2009 Corvette Z06 and ZR1: GM TechLink Article: Oil System Changes - LS7 and LS9

Changes have been made to the dry-sump engine oil system used in the 2009 Corvette (fig. 1) . This information pertains to these two engines:

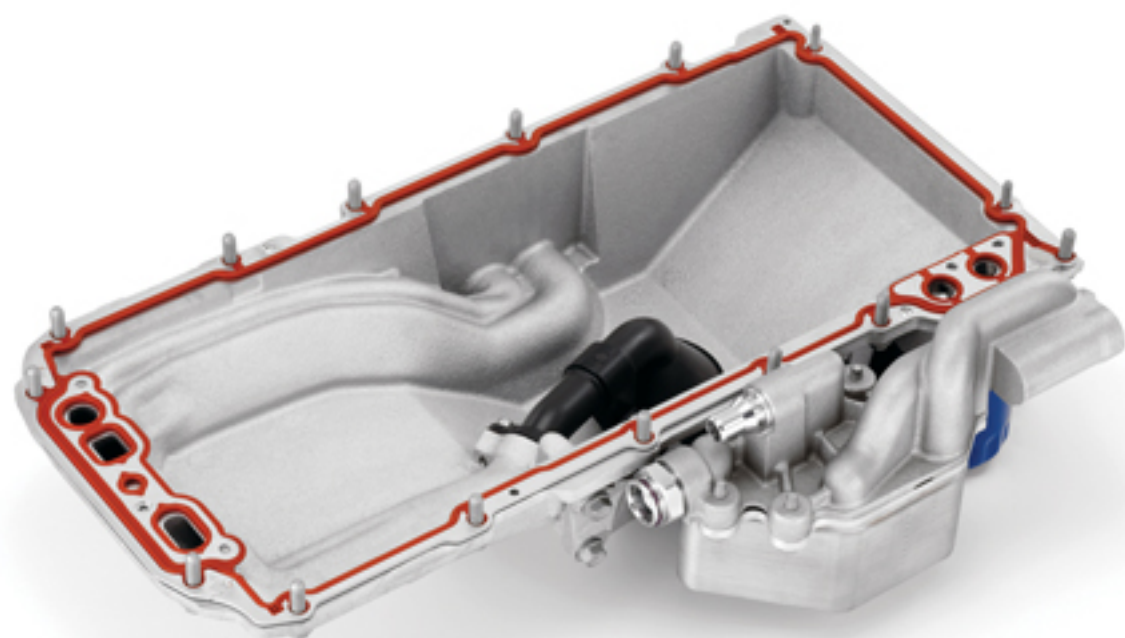
The dry sump system uses a dual gerotor oil pump, one rotor for scavenge and one rotor for supply (fig. 2) . The pump used on the LS9 produces greater volume and higher system oil pressure to provide adequate oil delivery under all conditions.

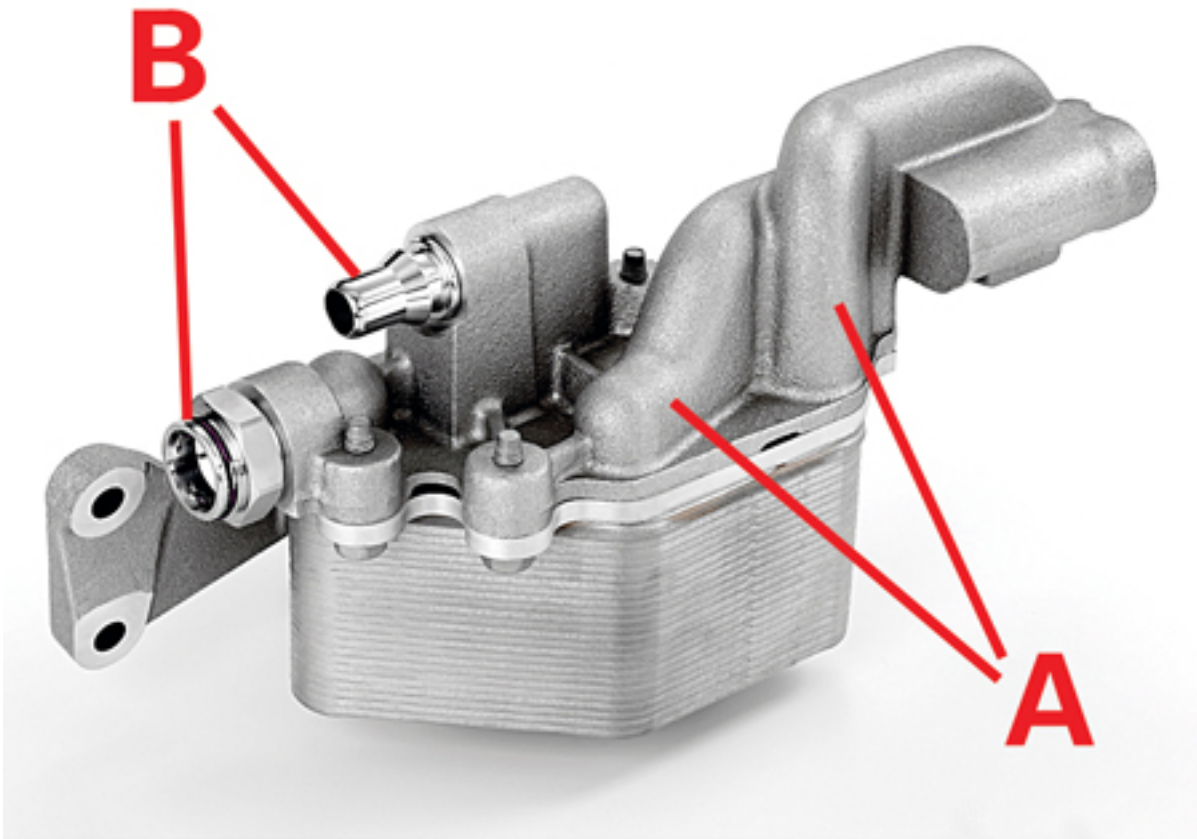
The LS9 uses eight oil squirters, one per cylinder, for additional lubrication of the pistons and cylinder walls (fig. 3) .

Both LS7 and LS9 use basically the same oil pan (fig. 4) . On the 2006-09 LS7, oil is routed from the pan to an external engine oil cooler located in front of the coolant radiator. The 2009 LS9 uses the same pan with a different design oil cooler that is mounted on the left side of oil pan (fig. 5) .

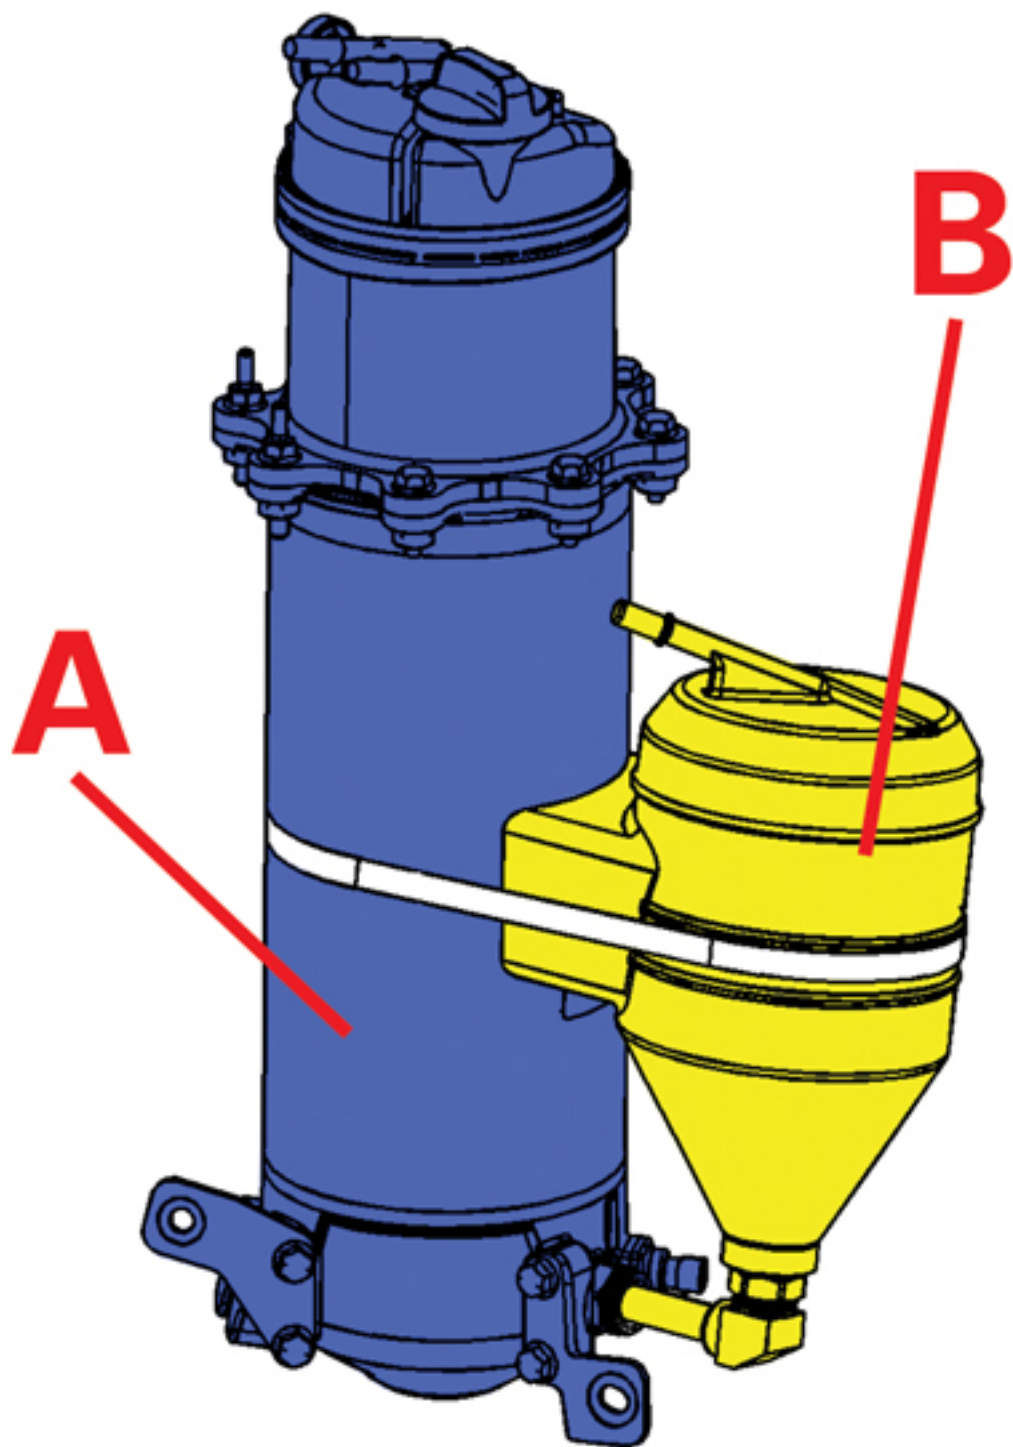
For both engines, the oil reservoir has been redesigned to increase the oil capacity of the system. Under extreme cornering loads such as experienced on a banked race track, extra oil capacity ensures that there is sufficient oil in the reservoir to avoid the ingesting of air due to slosh. A second tank is connected to the main tank by tubing (fig. 6) .
